RE: **STAFF SUMMARY REPORT**  
**LARGE-SCALE DEVELOPMENT PLANS – SHADOWBROOKE AT THE PEAKS PH. III**

Re: Conditional Approval of Civil Plans  
Shadowbrook at the Peaks, Ph.3

**Re: Shadowbrooke Phase 3 (CityView #PL201900667)**

SHADOWBROOKE AT THE PEAKS PH III  
LARGE SCALE DEVELOPMENT PLANS  
SITE & UTILITY PLAN  
ROGERS, ARKANSAS

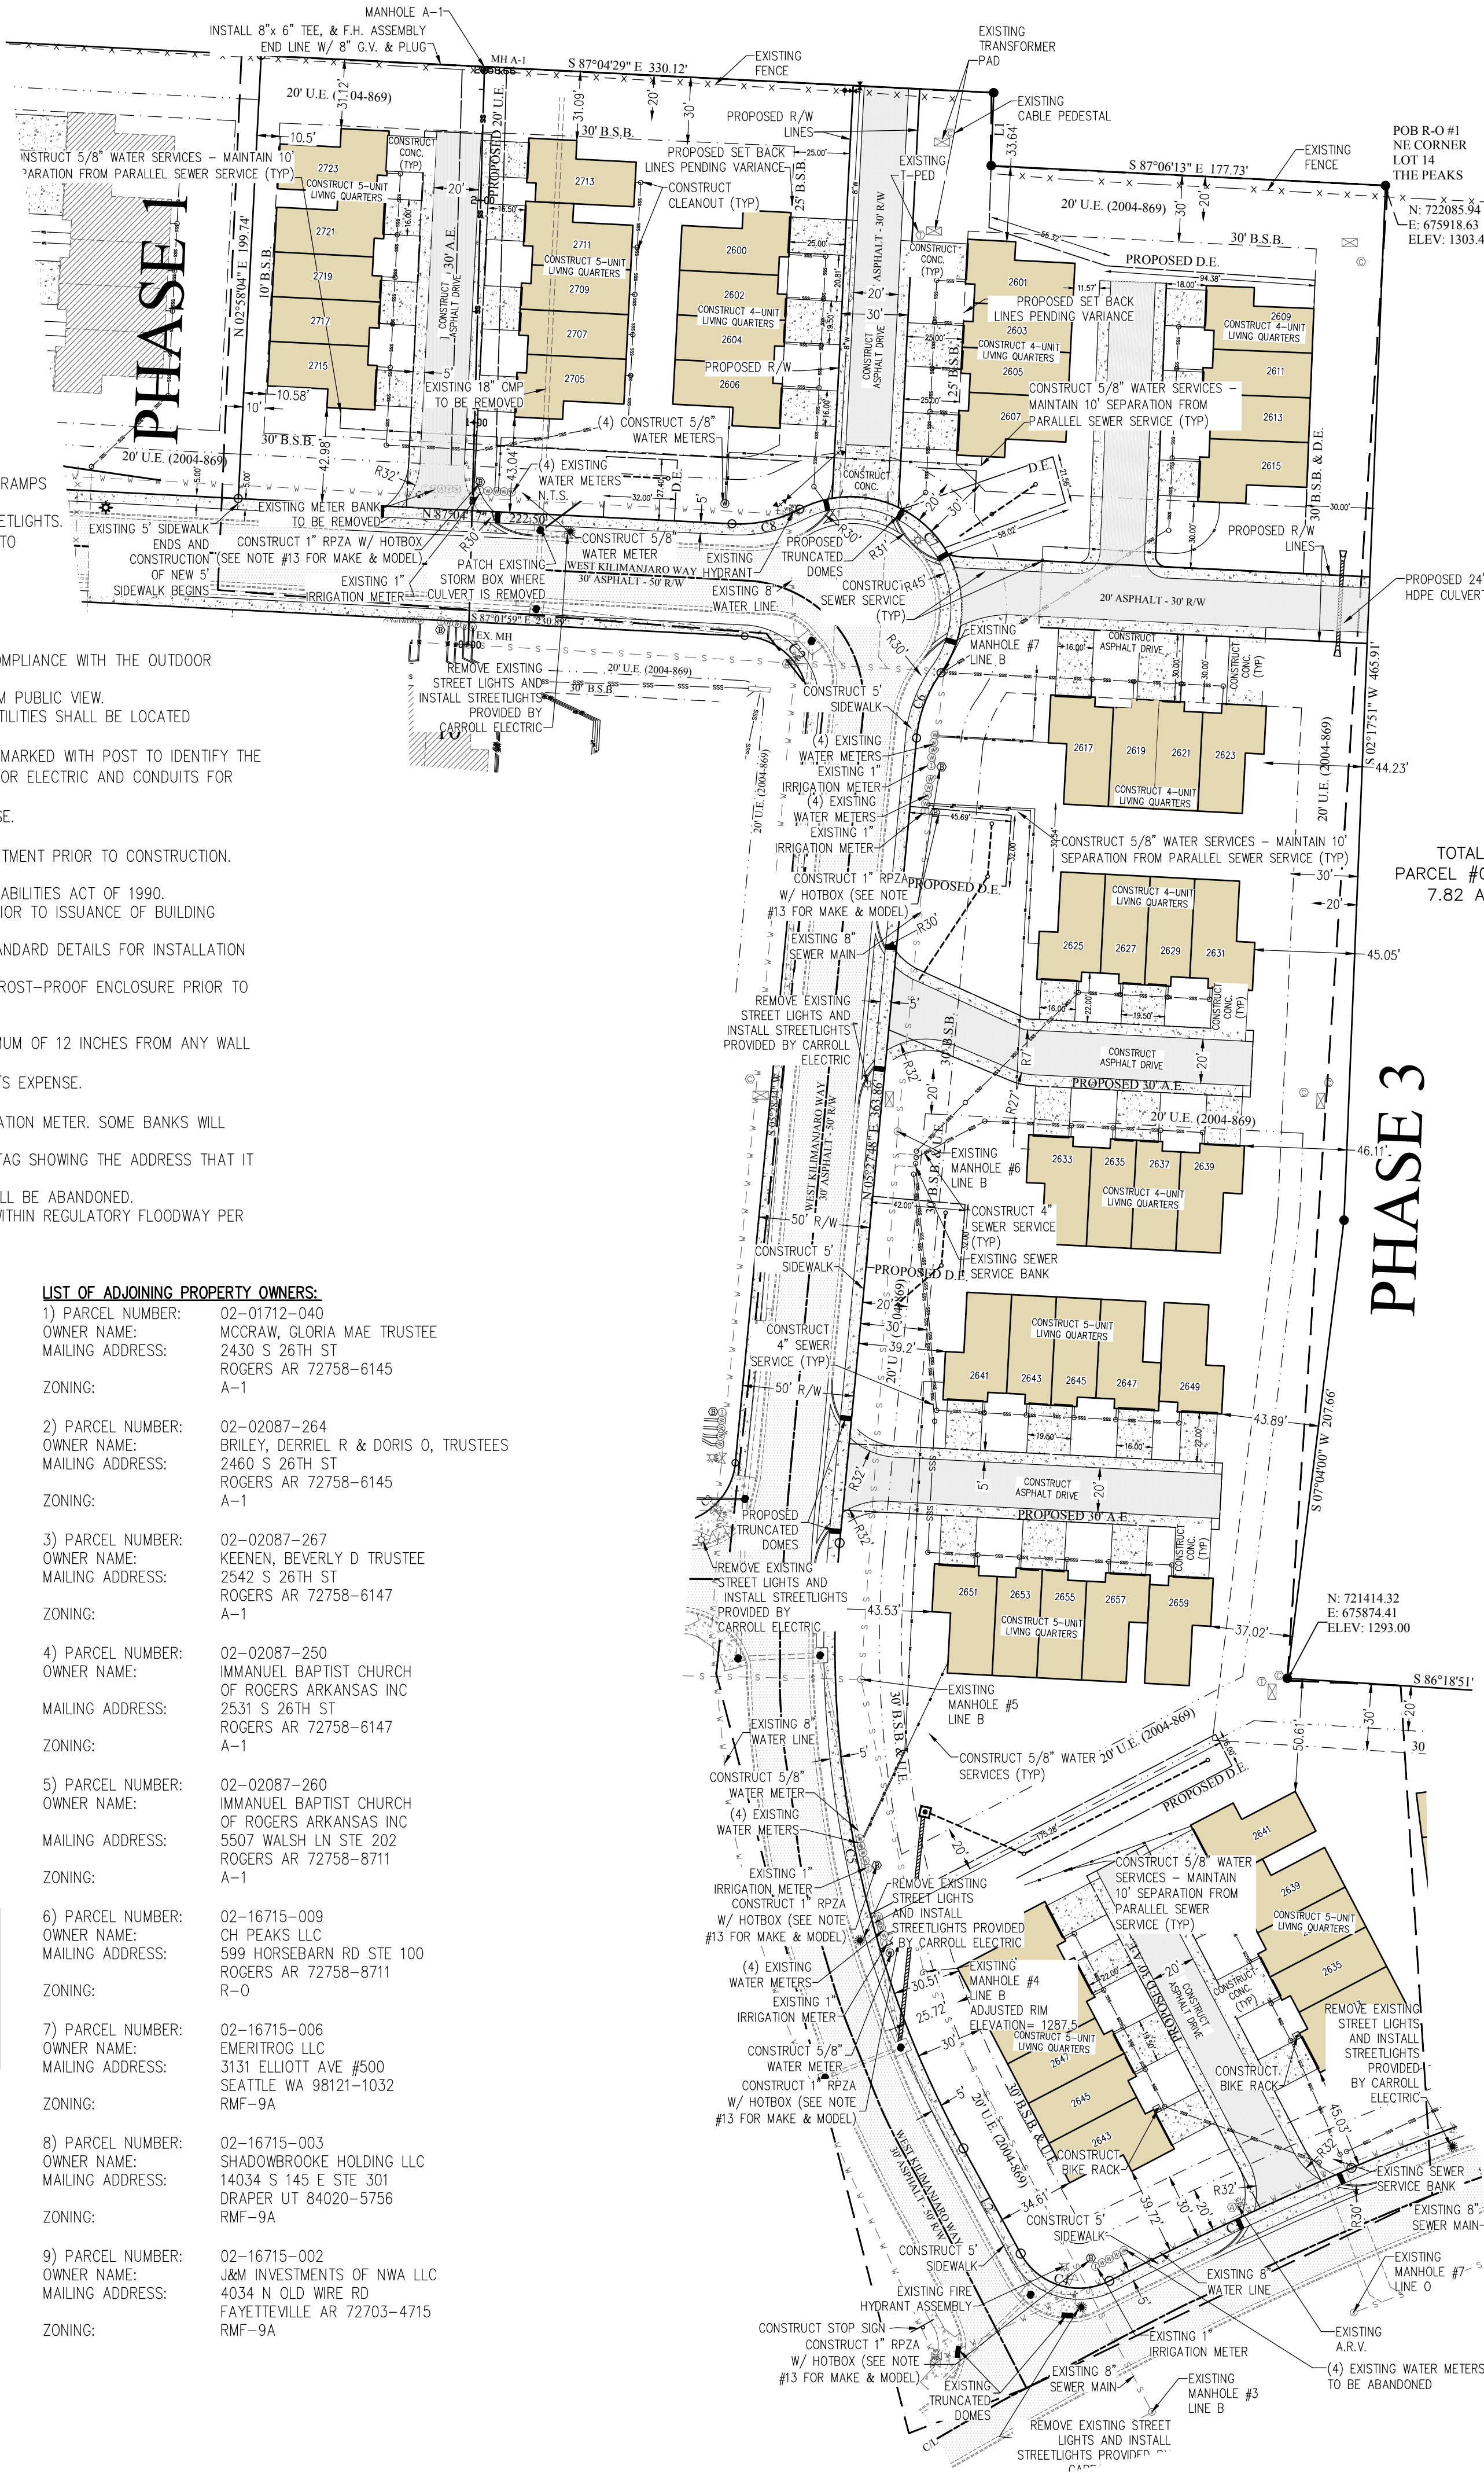
1. Locate the water extension to the north along the right-of-way where we required it in our previous review.
2. The two sewer services you are not using will need to be capped at the wye (main).

3. Provide a re-plat that reflects the changes to the utility easements.
4. Label manholes deeper than 14 feet to be six feet in diameter on the profiles. This vertical distance is measured from the top rim to the invert of the out-flowing pipe.

5. Label the grade lines on the profiles.
6. Replace the word "cap" with the word "plug" at the end of the proposed water main.
7. Label the proposed manhole numbers on the plan view of the Sanitary Sewer Plan & Profile.

8. There are proposed trees shown directly over the proposed water and sewer mains that will be over 20' tall at maturity. These trees must be located a minimum of 10' horizontally from the proposed mains.
